City of Albuquerque

RE: OLD TERMINAL ROAD AND PARKING LOT IMPROVEMENTS, PROJECT NO. 4135.90

**CONCEPTUAL DRAINAGE REPORT
AND SUBMITTAL FOR
SITE DEVELOPMENT PLAN APPROVAL
FOR THE
POSTAL FACILITY LOCATED AT
THE ALBUQUERQUE INTERNATIONAL AIRPORT**

RE: CONCEPTUAL DRAINAGE REPORT FOR THE POSTAL FACILITY LOCATED
AT THE ALBUQUERQUE INTERNATIONAL AIRPORT, SUBMITTED
JANUARY 10, 1989, FOR SITE DEVELOPMENT PLAN APPROVAL (DRB
89-549) (M-15/D27)

RUNDOWN SECTION

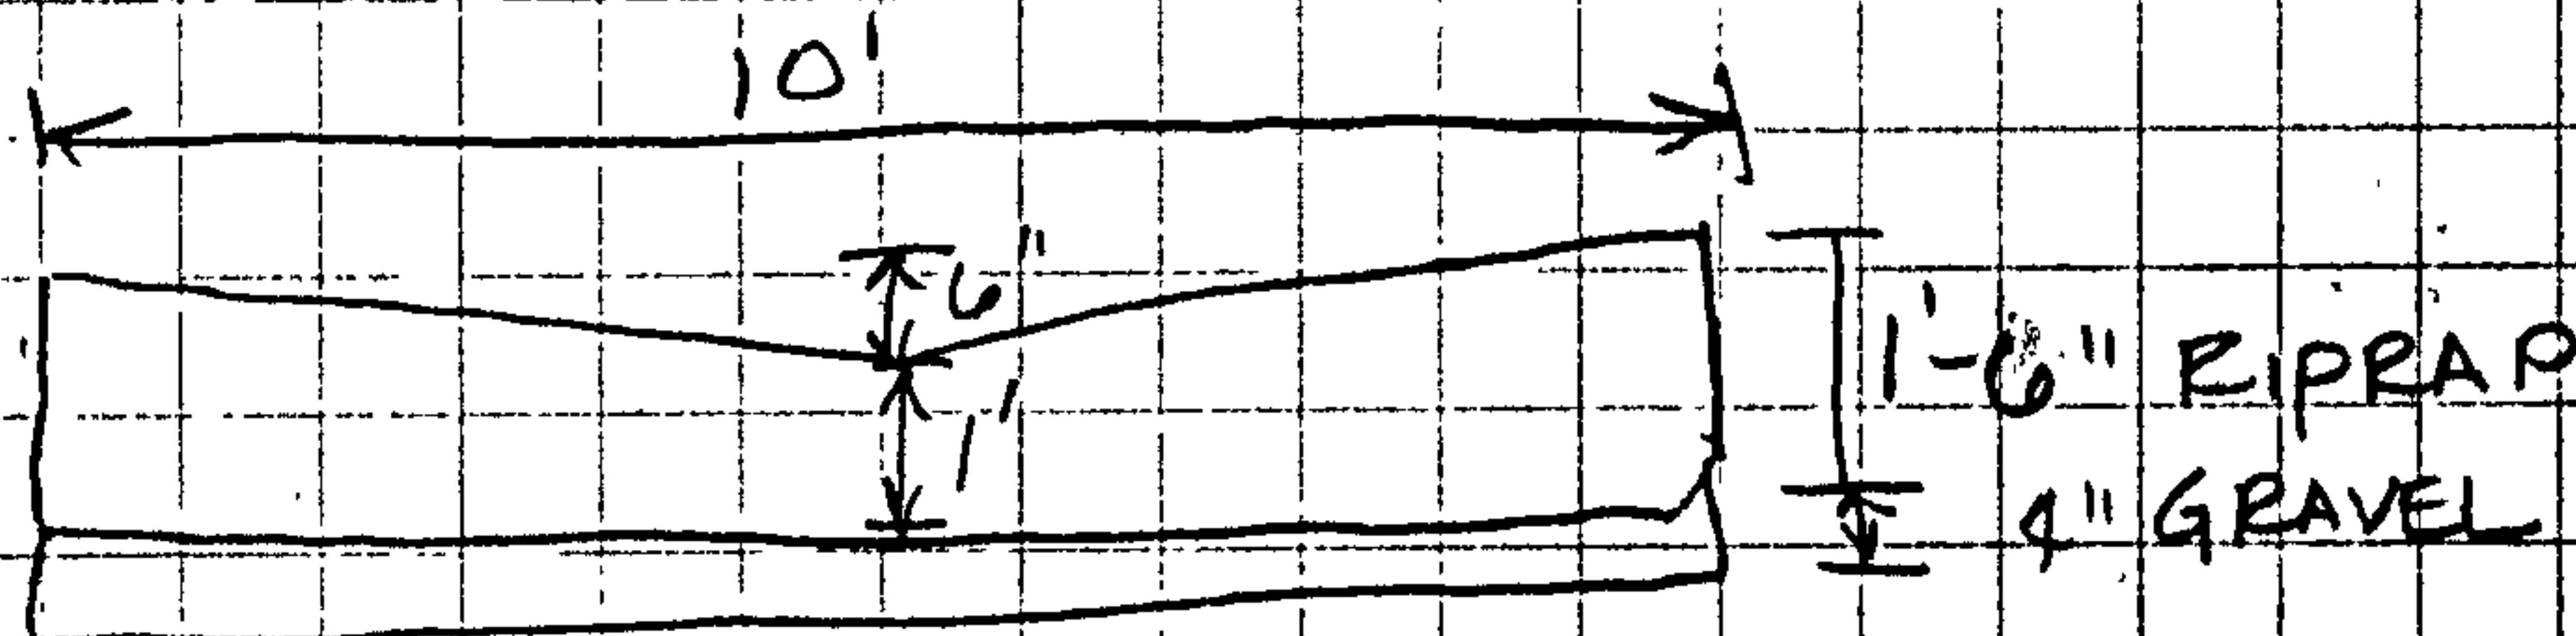
CHECK EROSION POTENTIAL AT RUNDOWNS LOCATED
AT AREA 1b AND OFFSITE AREA D

NORMAL DEPTH CALCULATIONS (ATTACHED) INDICATE
THAT VELOCITY = 8.9 FPS AT END OF RUNDOWN; SUFFICIENT
TO CAUSE EROSION. CHECK RIPRAP SECTION IN LIEU OF CONCRETE

RECOMMEND THAT RIPRAP RUNDOWN BE INSTALLED
RATHER THAN CONCRETE - REDUCES VELOCITY TO 4.2 FPS
RIPRAP SECTION SHOULD BE 1' THICK WITH 4"
OF GRAVEL UNDERNEATH
